## ARCHITECT'S SUPPLEMENTAL INSTRUCTIONS

<b>PROJECT:</b>	<b>Roosevelt Lofts</b> Historic Rehabilitation San Angelo, TX	<b>Report No.</b>	<b>Four (4)</b>
<b>OWNER:</b>	<b>Overland Property Group</b> 234 N. Santa Fe Ave, Suite A Salina, KS 67401	<b>Date</b>	<b>May 29, 2024</b>
<b>CONTRACTOR:</b>	<b>MCP Group</b> 3501 SW Fairlawn Rd. Topeka, KS 66614	<b>Architect's Proj No.</b>	<b>22-3281</b>
		<b>Contract For:</b>	General Construction Mechanical, Electrical

**A** THIRD FLOOR REFLECTED CEILING PLAN  
1/8"=1'-0"

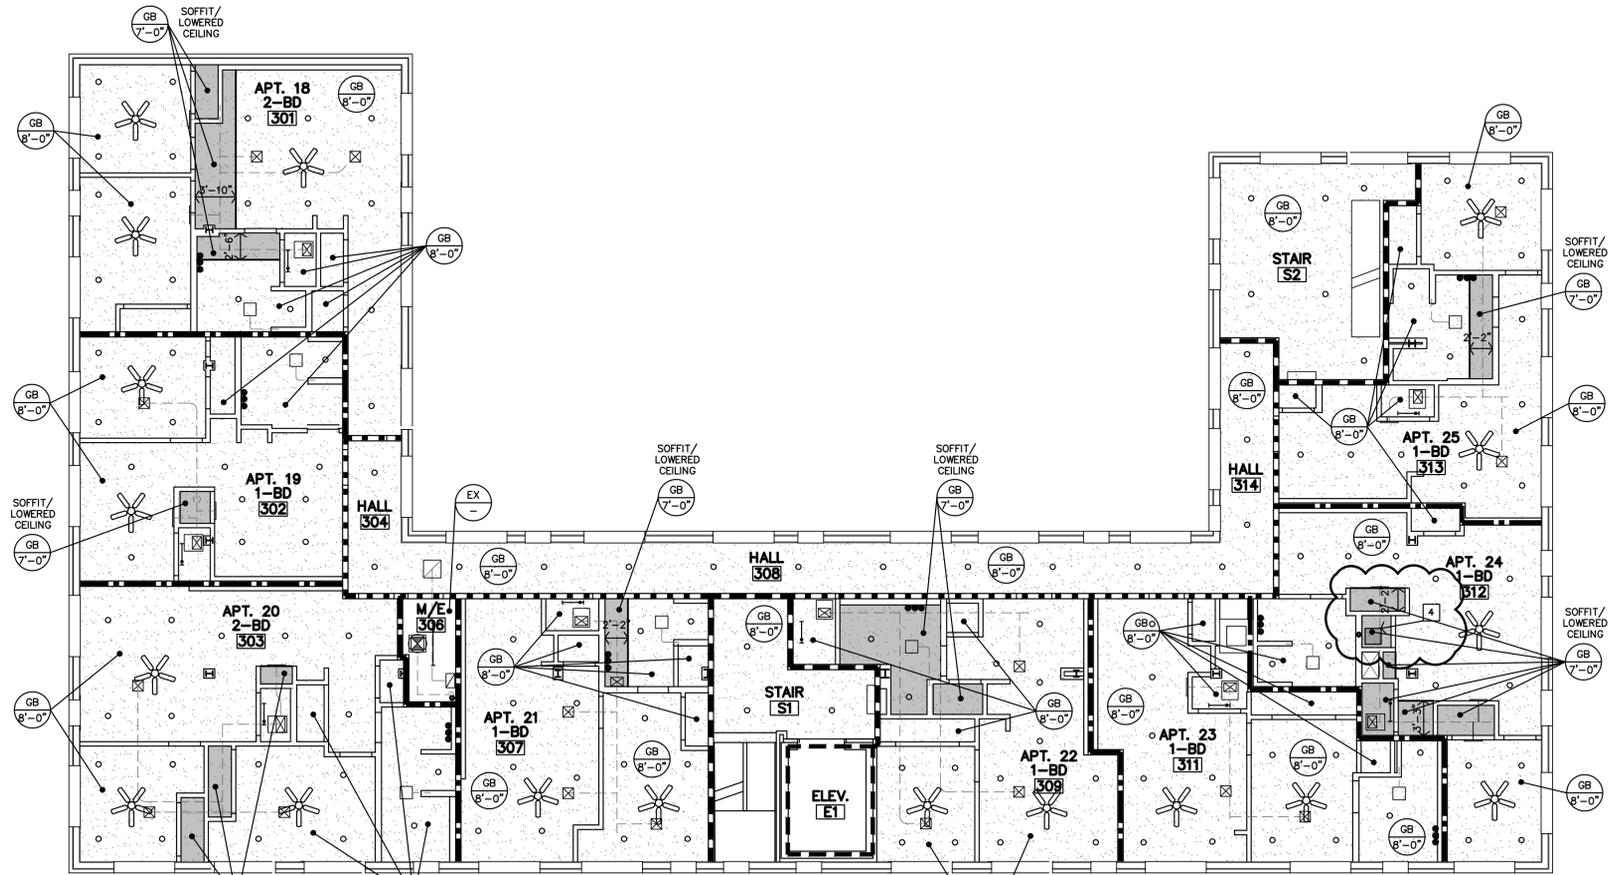
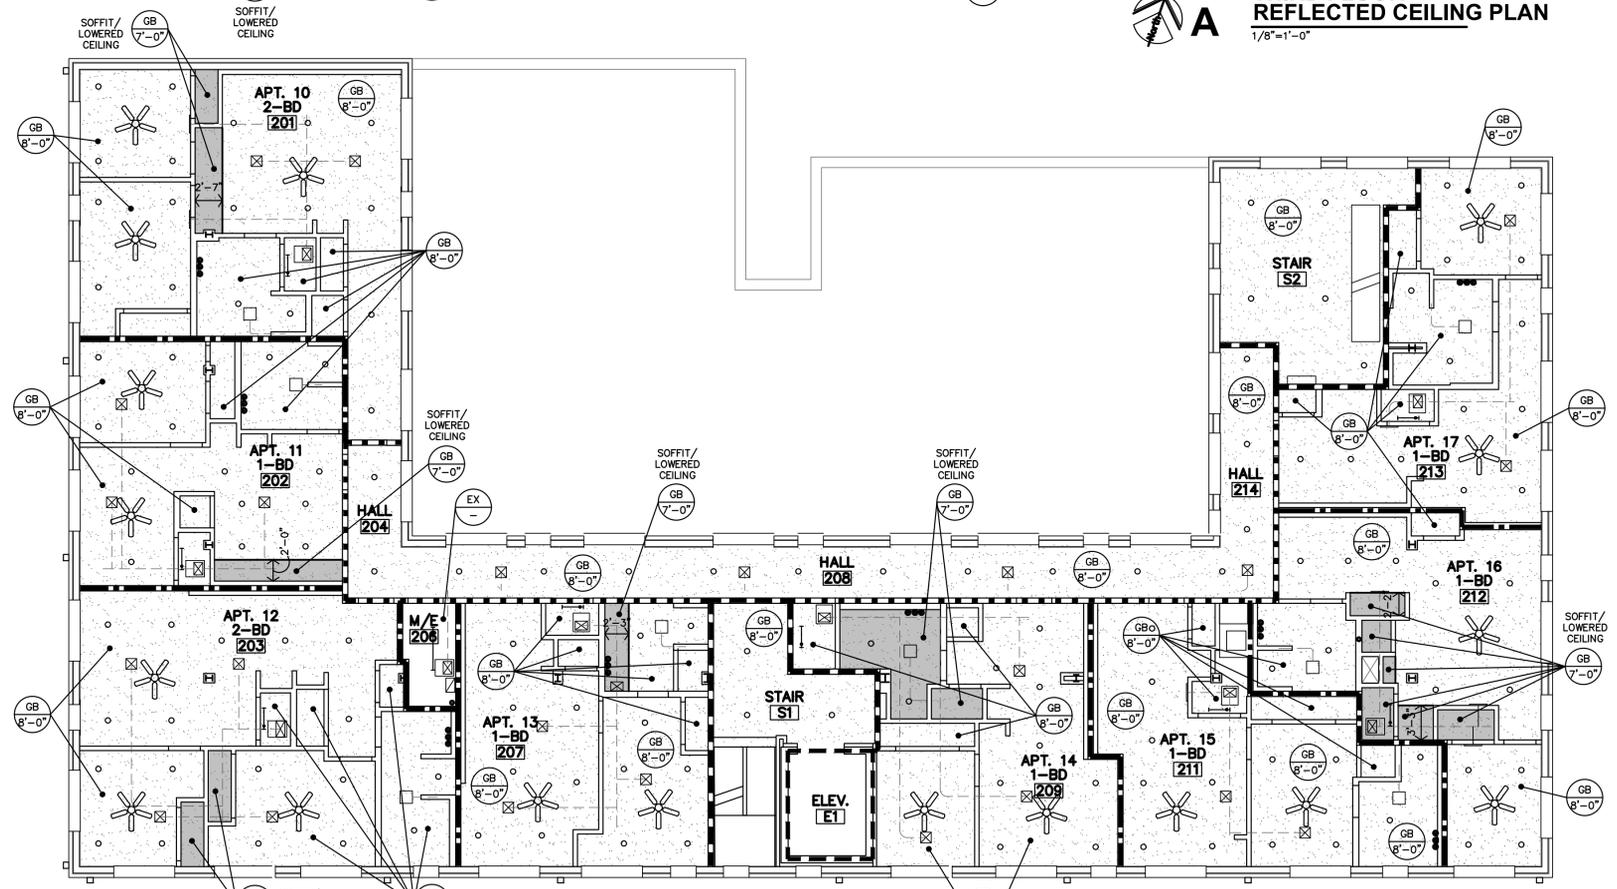
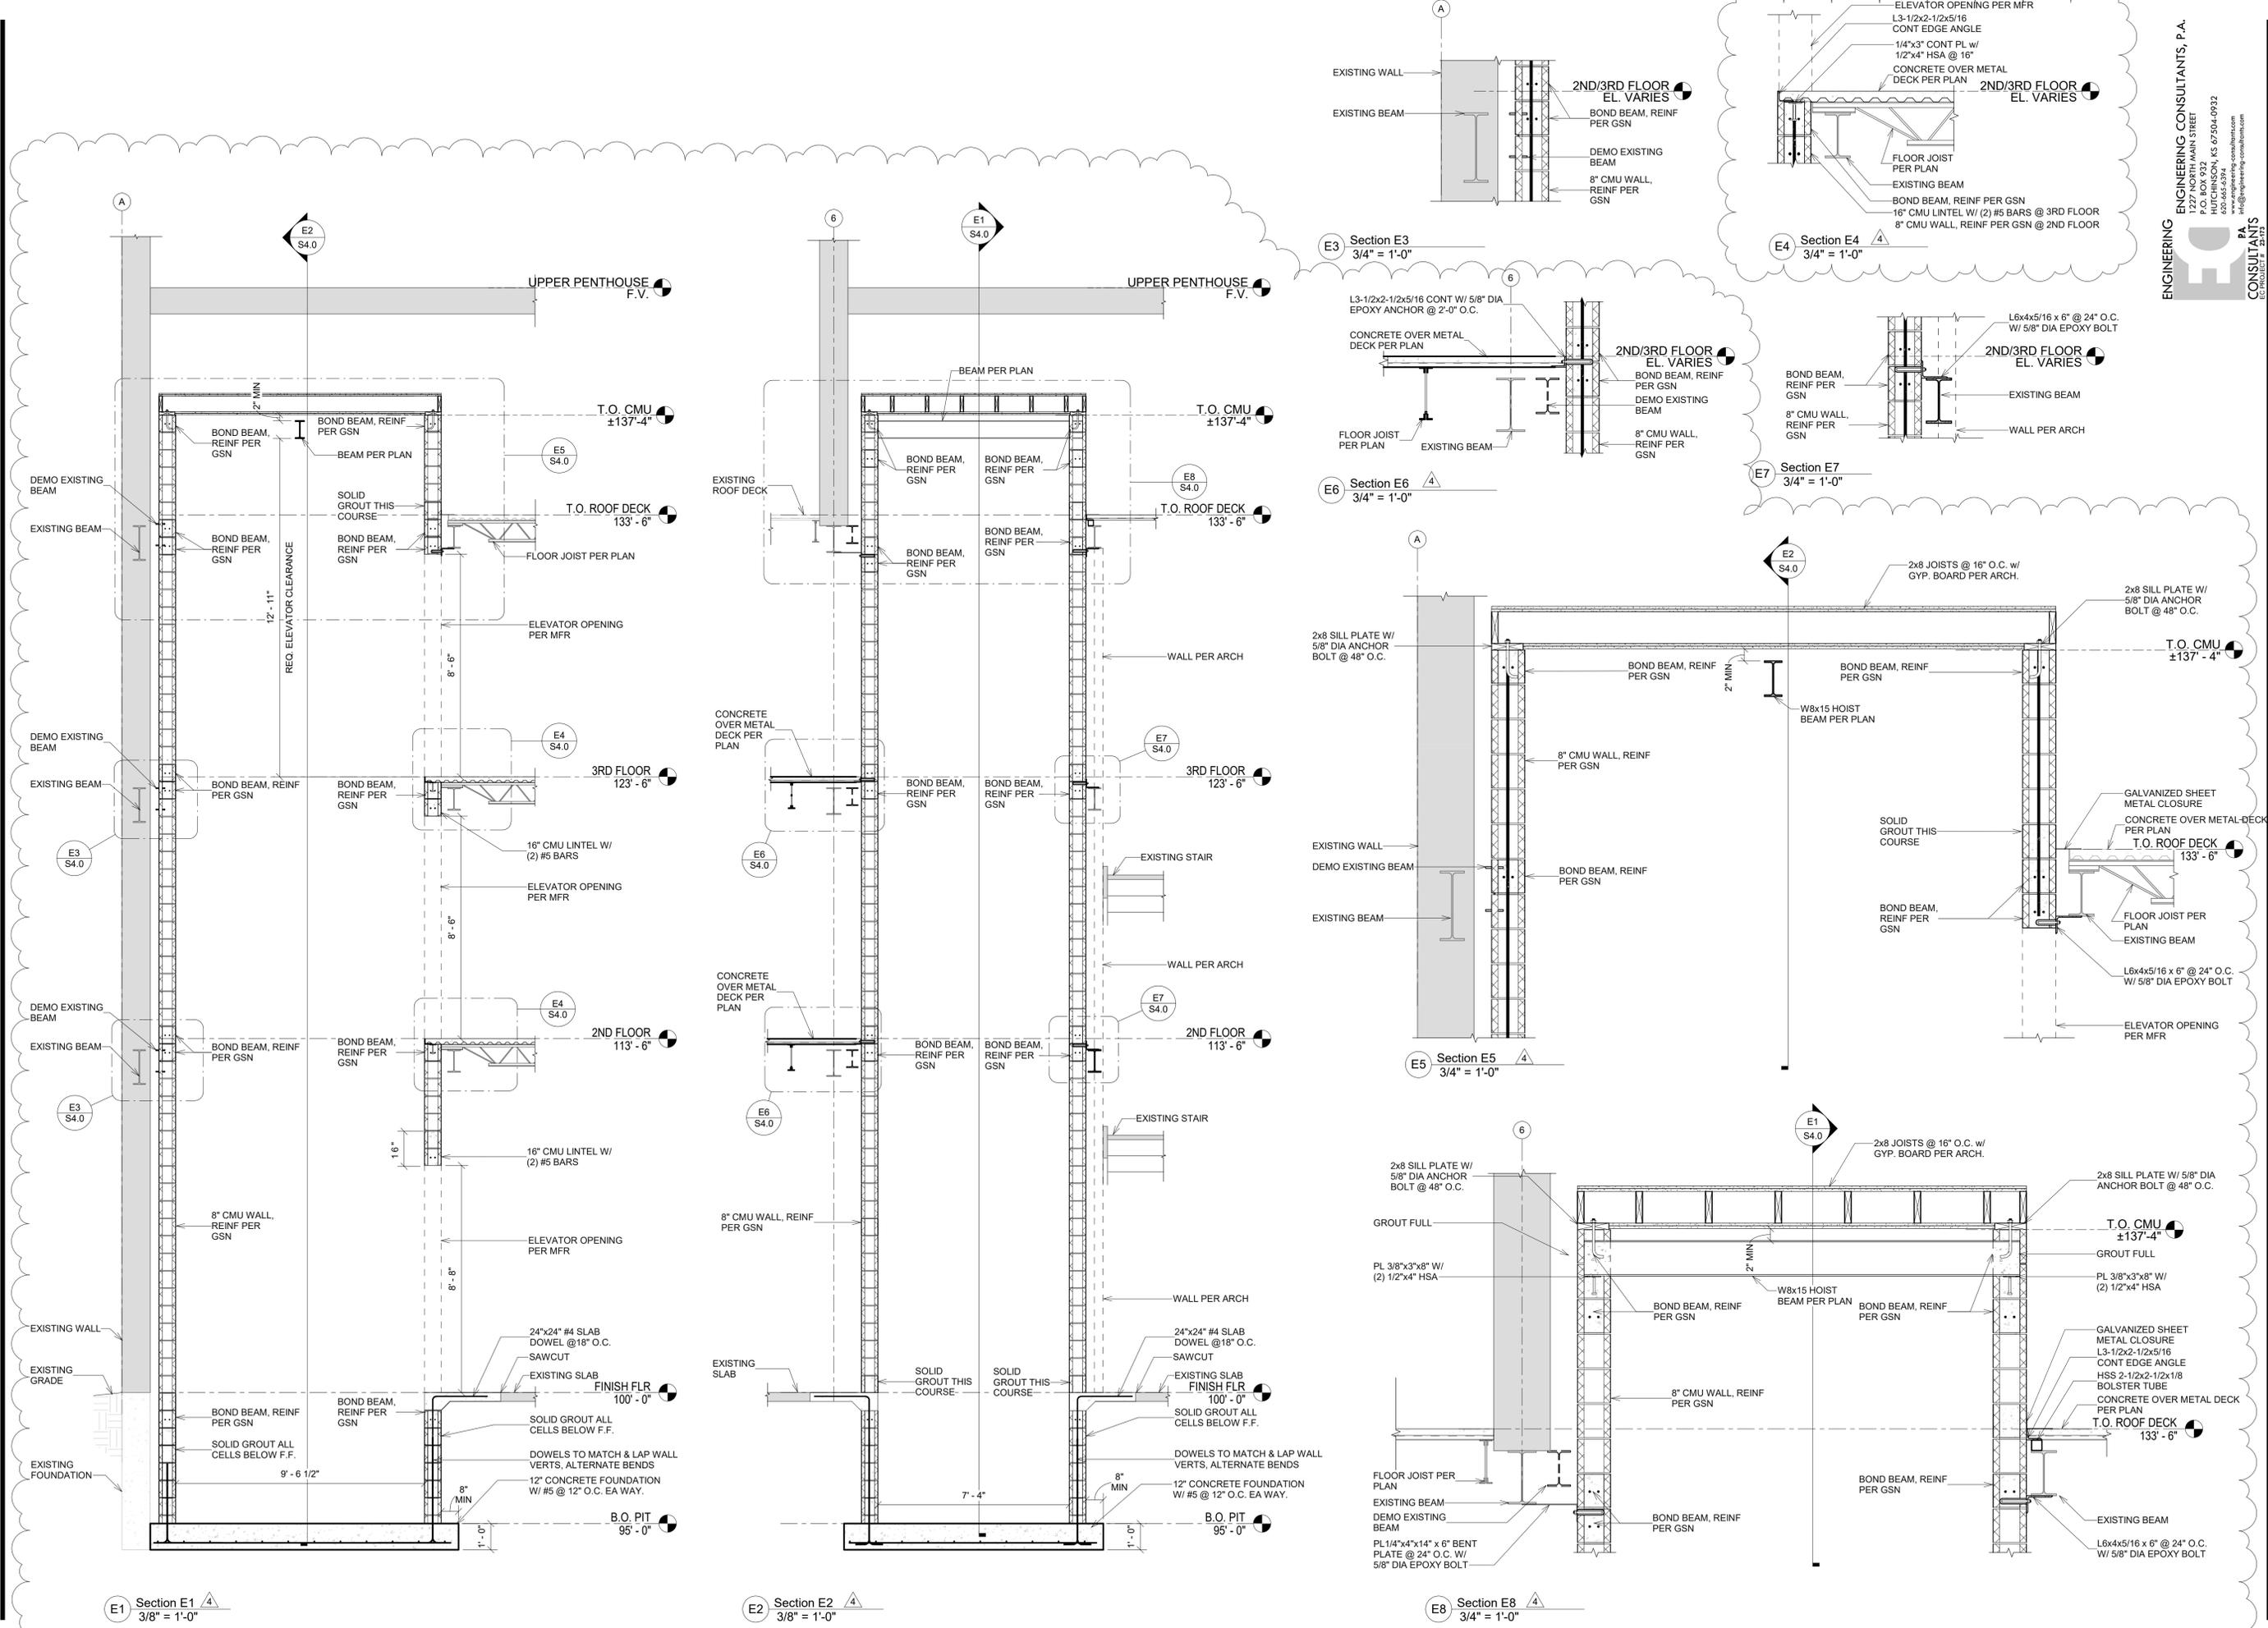
- viii. Sheet A7.2 – Added an access panel to the ceiling of the laundry room in Apt. 24 (#312). Added Note #4.
  - d. Sheet A6.1
    - i. Details A, B, C & D - Elevator shaft size (width) has been reduced from 7'-8" (original designs) to 7'-4" to coordinate with elevator manufacturer's details/shop drawings. East wall of shaft shifts 4" to the west. The location of the west shaft wall does not change per the original designs.

**E1.1**

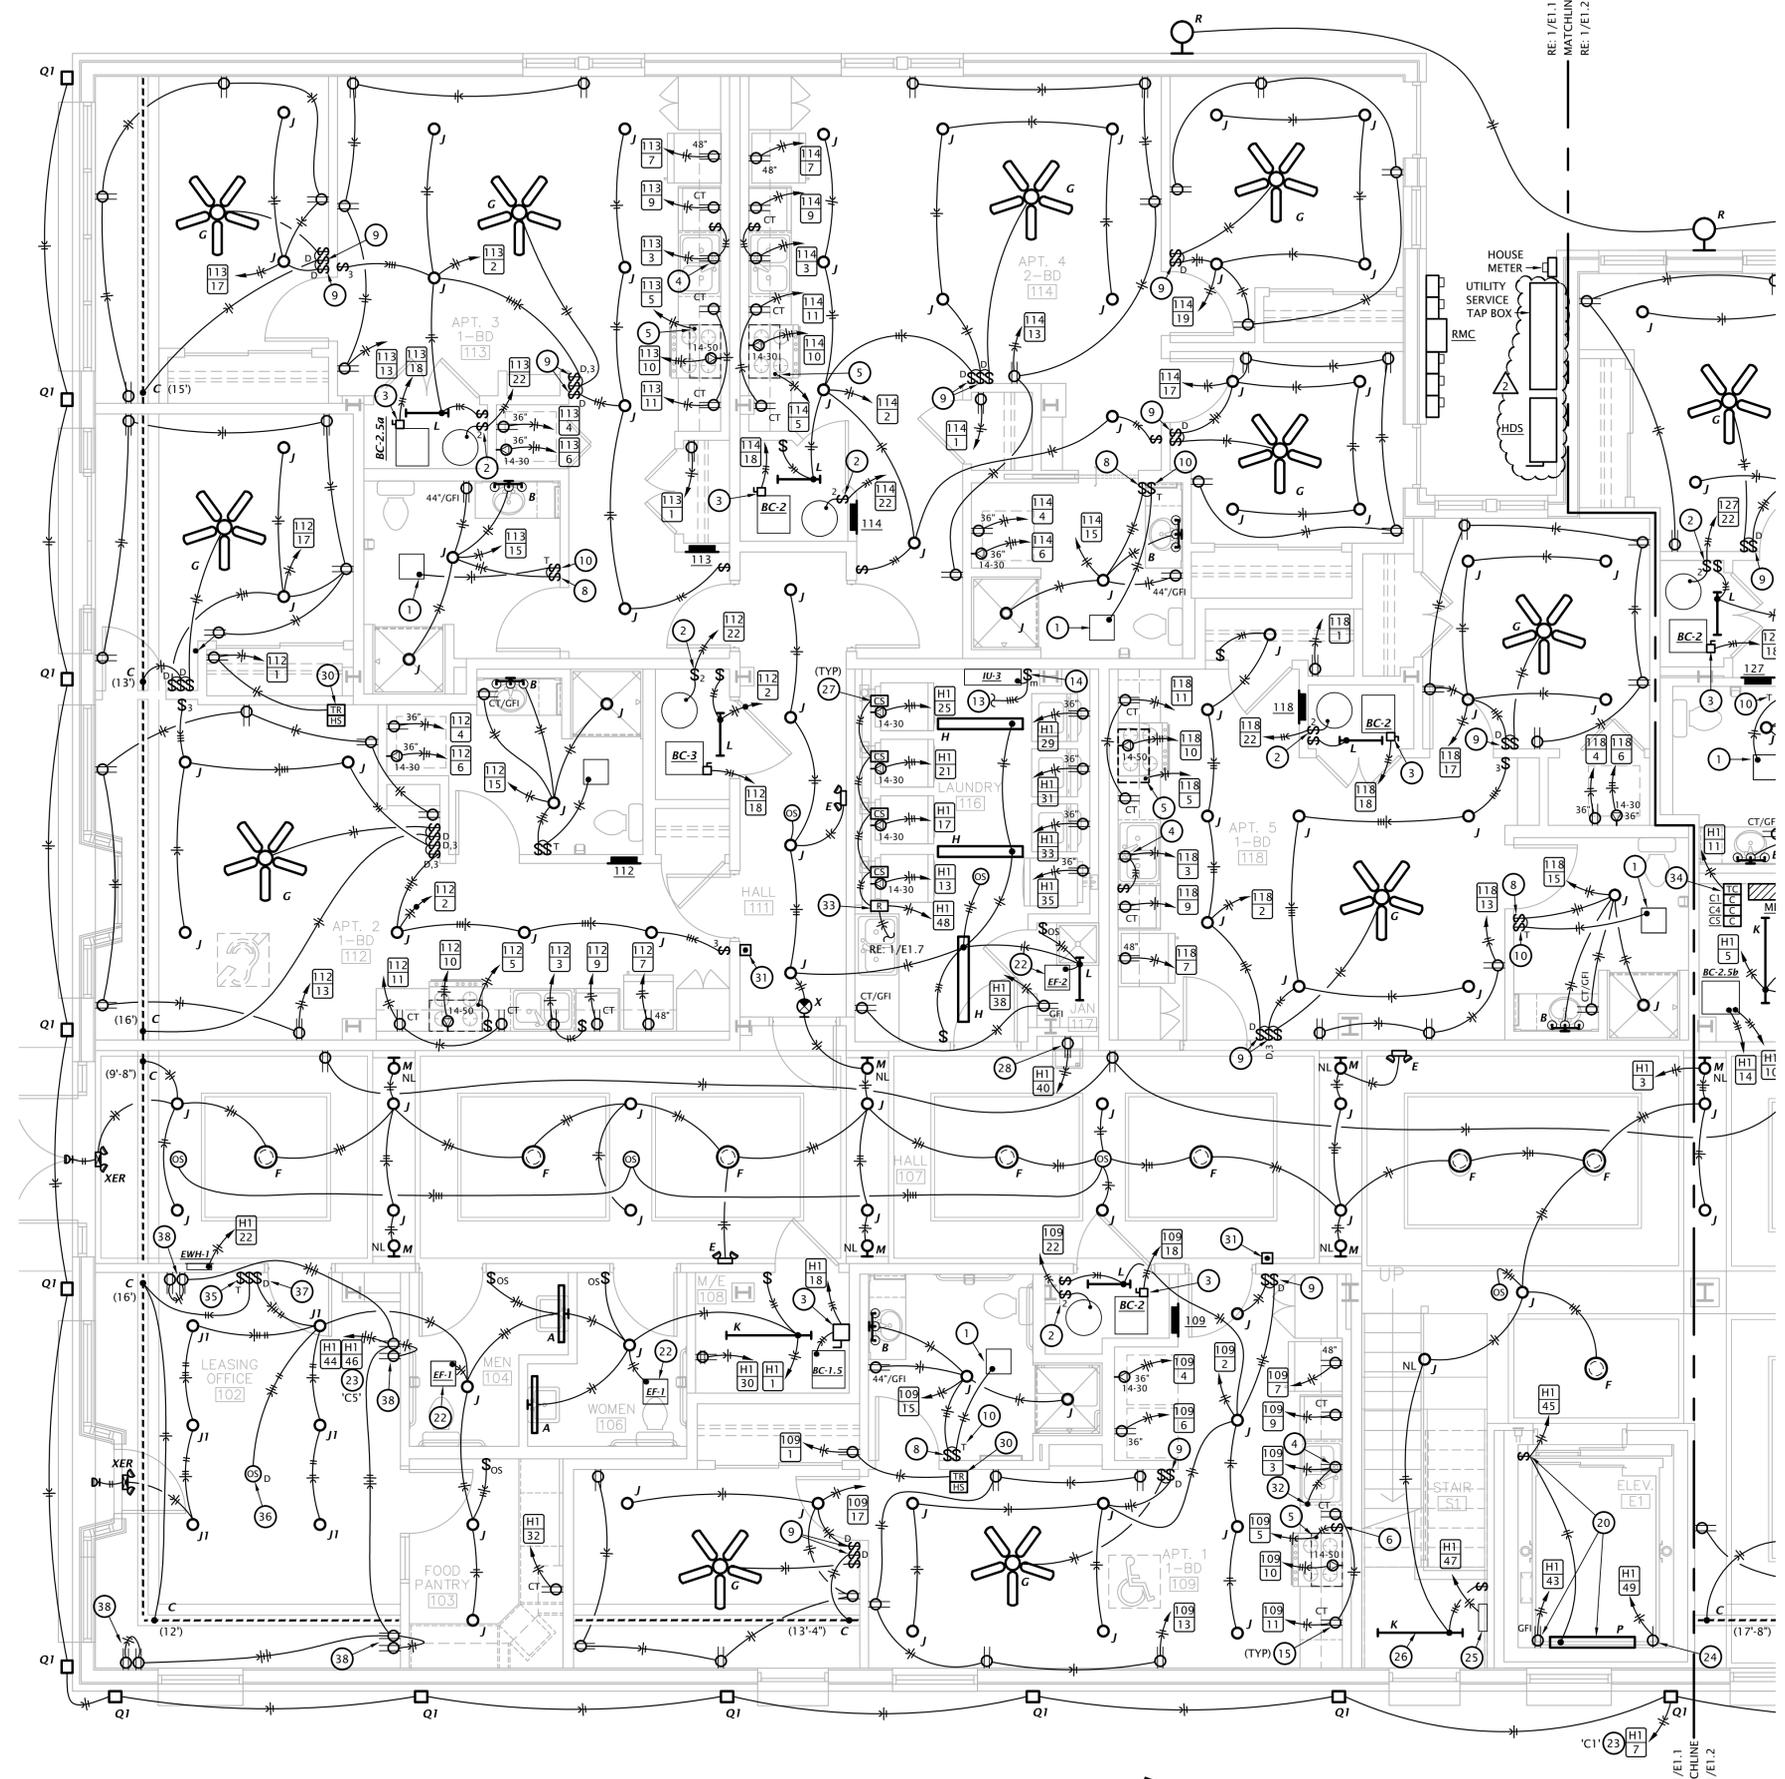
- g. Sheet E1.1
    - i. increased sizes of utility service tap box and service disconnect switch 'HDS' on plan.

**1 ELECTRICAL RISER DIAGRAM - SERVICE EQUIPMENT**  
 No Scale

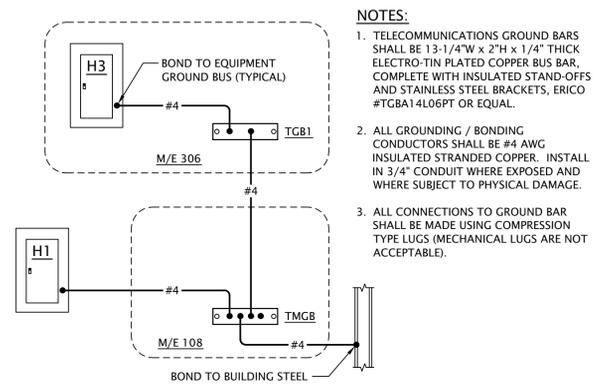
- i. Modified service equipment power riser diagram to increase house service to 800 amps
  - ii. Modified house distribution power riser diagram to show power feeder to elevator controller at second floor landing.
